SERVICETEKNOTES

TABLE OF CONTENTS

DC5010 H.F. COUNTING FLUCTUATES BY
4 OR 5 LEAST SIGNIFICANT DIGITS

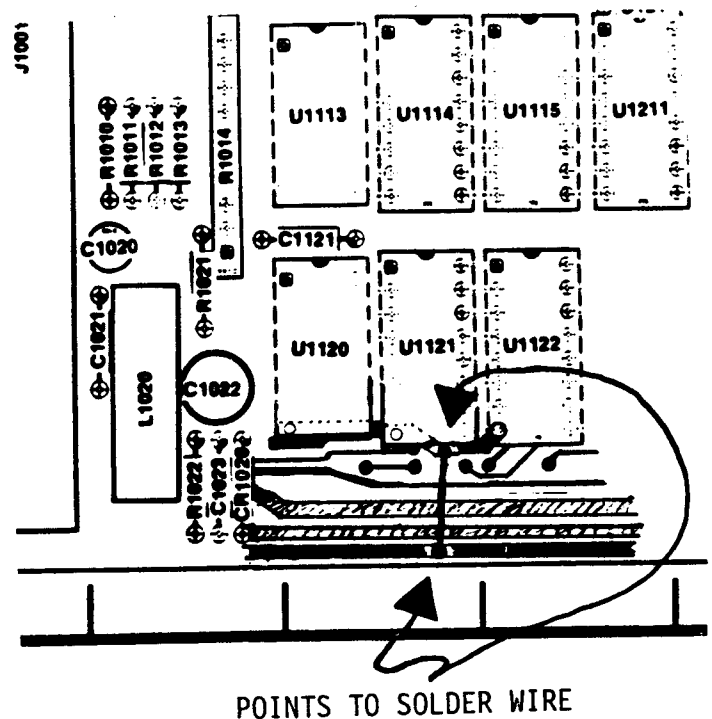
Fluctuation of >10kHz on the last four to five L.S.D.'s may occur when measuring frequencies between 100MHz to 350MHz (the symptom normally shows at 350MHz). First, vary the signal source to ensure it is not the cause of the erratic display. If the source is stable,

then the following modification should be done to improve the display:

1) One end of an insulated wire is soldered to the ground plane run located on the bottom front of the A16 Digital Board. See the diagram for the exact location.

(Scrape the solder mask from the run at the point of soldering, being careful not to damage the run. Too much heat on the run can separate it from the board, so use care when soldering.)

2) Solder the other end of the wire to the ground plane which attaches together Pin 7 of U1120 and Pin 8 of U1121 and U1122. (Follow the soldering procedure in Step 1.)

In some extreme cases U1120 may be part of the noise and will have to be replaced.

R230 100% MEMORY RANGE, R1154

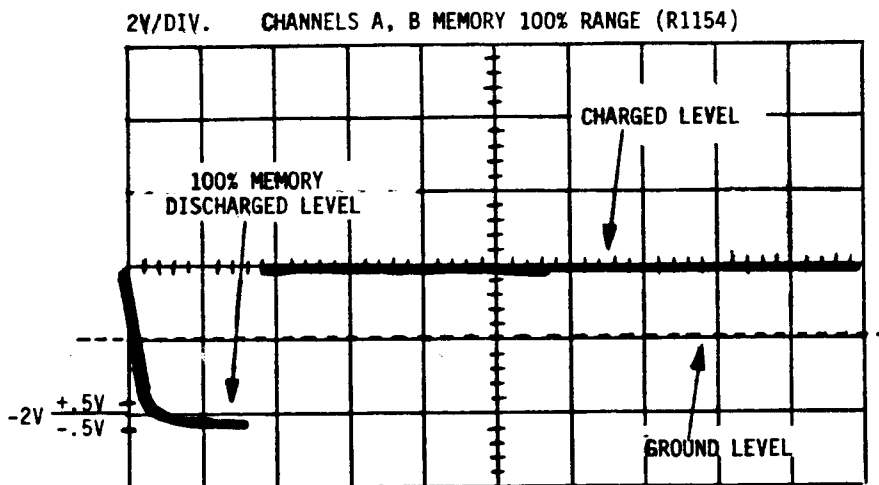
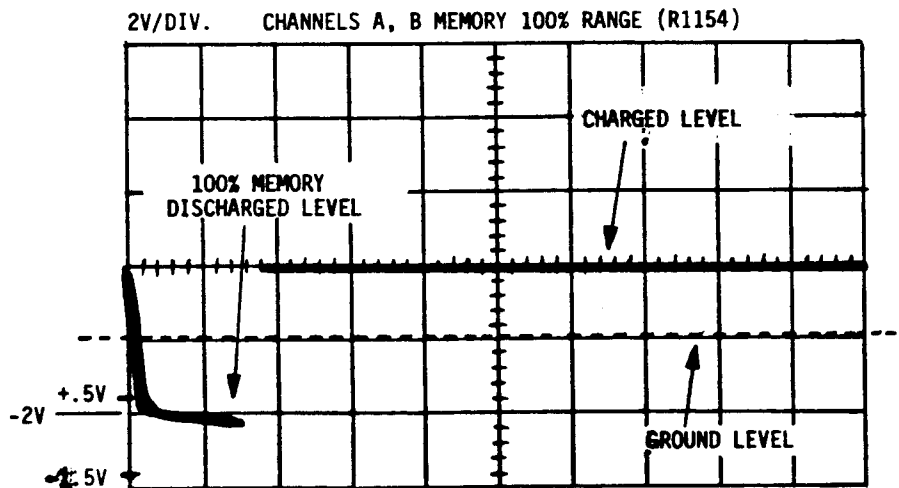
The 100% memory range test and adjustment section of the 070-1976-00 manual includes a check procedure for the 100% memory discharge voltage level. Section 9 on pages 7-6 and 7-7 checks and adjusts R1154 for a -2 volt level (with a ± 0.5 volts tolerance) below ground reference.

The tolerance range for the -2 volt (R1154) adjustment has been changed from ± 0.5 volts to to + 0.5V through -1.5V from the -2 Volt level. From Ground reference, the R1154 Adjustment range is -1.5 Volts to -3.5 Volts.

In some instances when Q1155 (151-1002-00) is a Motorola part, the wider tolerance range is necessary. The increased tolerance window will not affect memory operation or operating specifications.

070-1976-00 FIG. 7-4 (B)
 OLD ADJUSTMENT RANGE LIMITS -2V ($\pm .5V$)

070-1976-00 FIG. 7-4 (B)
 NEW ADJUSTMENT RANGE LIMITS -2V (+.5V, AND -1.5V)

690SR/6942 HI RATE OPERATION

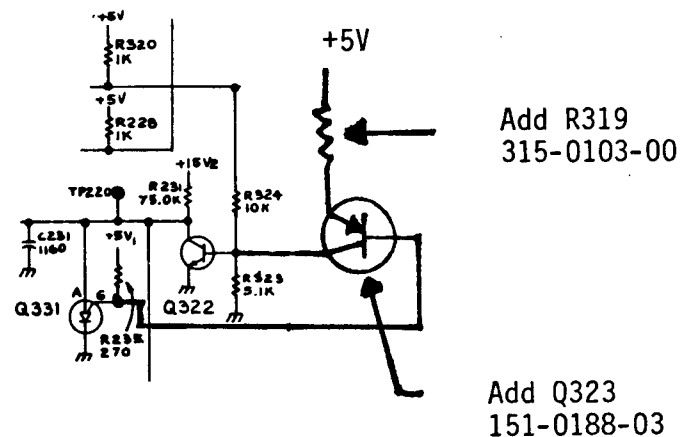
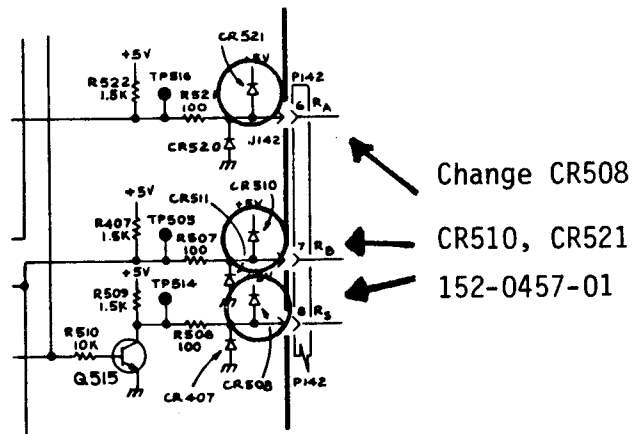
Starting at S/N B011080 on the 6942 and B010410 on the 690SR, a mod was implemented to take care of three problems in the instrument. These changes all occur on the H Delay board, A11 A2.

1. At high scan rates (37.5 kHz) the unit would not always function properly since U332 was in voltage limit prior to the retrace command occurring. To correct this, VR335, an 11 volt Zener diode was added in parallel with C335, cathode to the U332-pin 6 end of C335 (see diagram).
2. To improve reliability, CR508, CR510 and CR521 were changed to burned-in parts (see diagram).
3. With the monitor set for a high scan rate mode, it occasionally would not free-run with the interface module removed. This was caused by the valley current of Q331, a Programmable-Unjunction Transistor, being too low in some devices. To eliminate the need to select Q331 for proper operation, a kit (050-1675-00) has been established that will add another transistor and a resistor in a "teepee" fashion to the circuit. This will insure high-rate, free-run capabilities. (See diagram.)

2215 ALTERNATE SWEEP BOARD SHIELD REMOVED

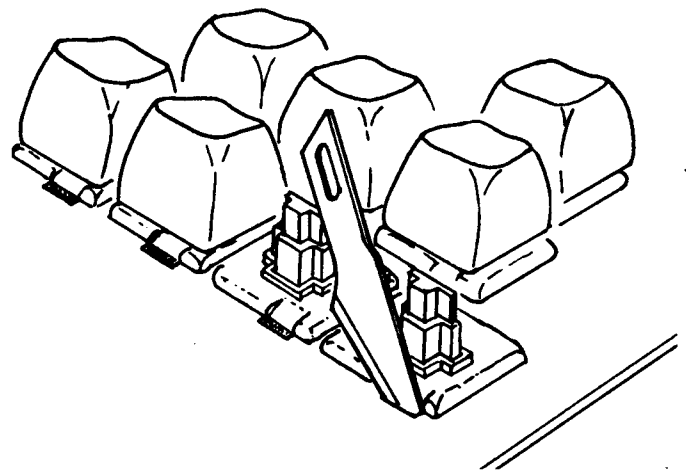
RE: FIG 2 - 15
S/N B027295

The A13 Alternate Sweep board shield has been removed from all 2215 scopes above the listed serial number. It has been determined that it was not needed for either electrical or mechanical reasons.

Use of the shield in units below this serial number is optional.

4006/4010/402X/405X CHERRY KEYSWITCH REPLACEMENT

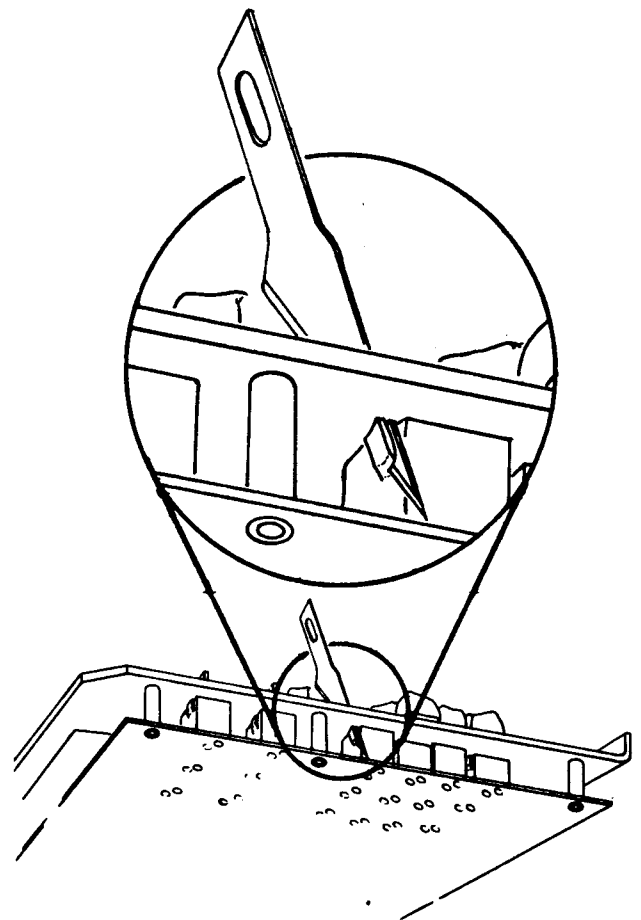
The late style cherry keyswitch, with the expanding mounting tabs, is difficult to remove from the keyboard without first cutting the mounting tabs off.

Older keyswitches have bumps, rather than locking expanding tabs; therefore, do not require cutting.

It has been found that the X-acto blade #11, 002-1040-00, with the long straight edge, works quite well in cutting the cherry keyswitch tabs. Insert blade in keyboard as pictured and cut off tab.
